Serial No. : 10/809,198

FOR : OPTICAL DEVICE WITH LENS POSITIONING AND
METHOD OF MAKING THE SAME

AMENDMENT TO THE DRAWINGS

FIG. 10

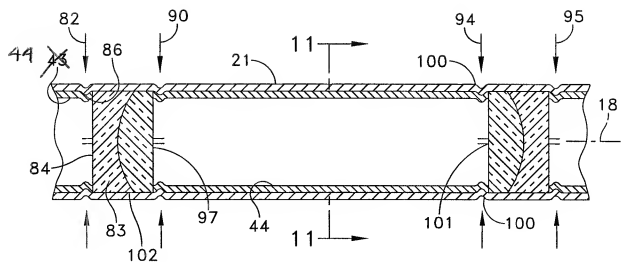
The Examiner notes that in FIG. 10 it appears the numeral "43" at the top left corner should be -- 44 --. Applicants are submitting an Amendment to the Drawings to correct this error.

Please amend FIG. 10 the above-identified patent
application as follows:

Delete "43" and insert -- 44 --.

A copy of the amended drawing is attached. The requested
changes are annotated. Applicants are also submitting a new
formal drawing for FIG. 10.
